January 4, 2006

**RE: Pre-Hearing Submissions Requested by the Office of Planning, ZC Case No. 05-36
(First Stage & Consolidated PUD & Related Map Amendment-200 K Street N.E.)**

UNION PLACE

A1.11

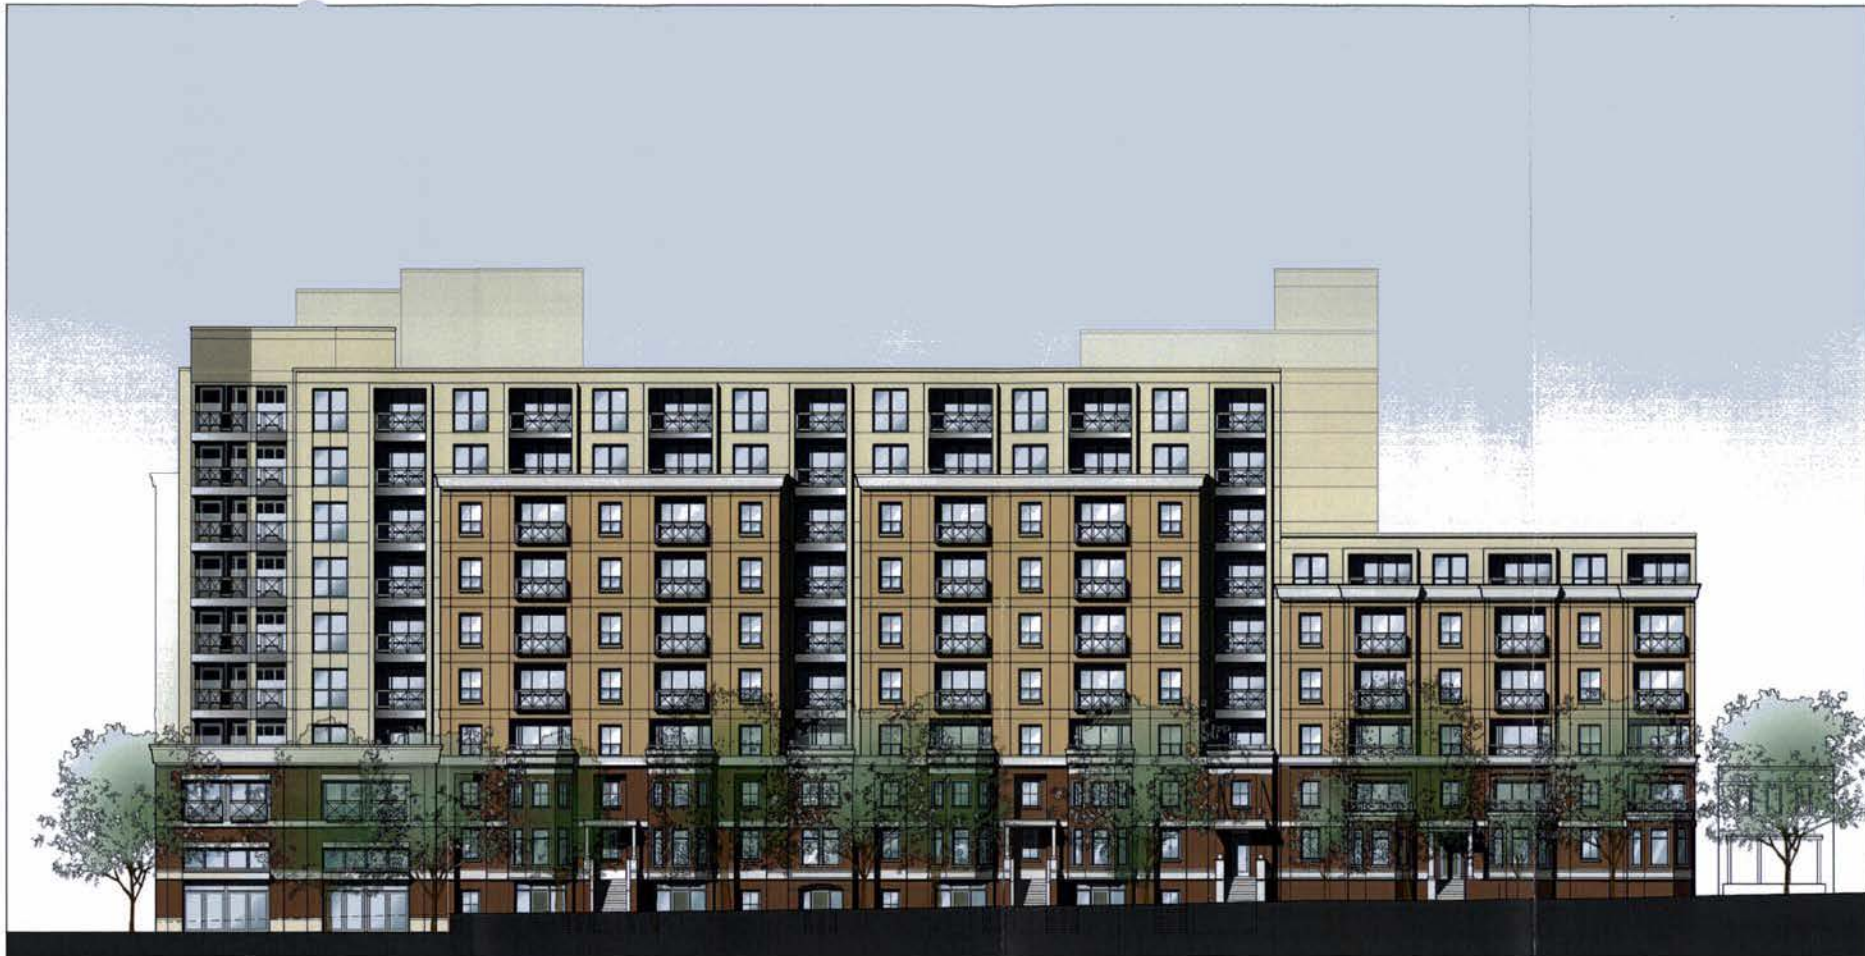
Applicant Response: The Zoning Regulations require that rooftop mechanical equipment and stairway and elevator penthouses "shall be set back from all exterior walls a distance at least equal to its height above the roof upon which it is located" (§ 400.7 (b)), "shall not exceed eighteen feet, six inches (18 ft., 6 in.)" above the roof (§ 400.7(c)), and shall comply with the provisions of § 411. Section § 411.3 requires that "all penthouses and mechanical equipment shall be placed in one (1) enclosure..." However, § 411.4 provides that "when roof levels vary by one (1) floor or more or when separate elevator cores are required, there may be one (1) enclosure for each elevator core at each roof level."

In response, the Applicant revised the Phase 1 roof plan to conform to the regulatory specifications. The revised Sheet A1.11 and revised Elevations (Sheets A2.00, A2.01, and A2.02) reflecting the roof-plan changes are provided in Attachment 2. The revised plans show that the mechanical equipment and elevator/stair towers are consolidated into one roof structure atop the ten-story portion of the building and a second roof structure atop the seven-story portion. Due to these changes, we think a variance is unnecessary.
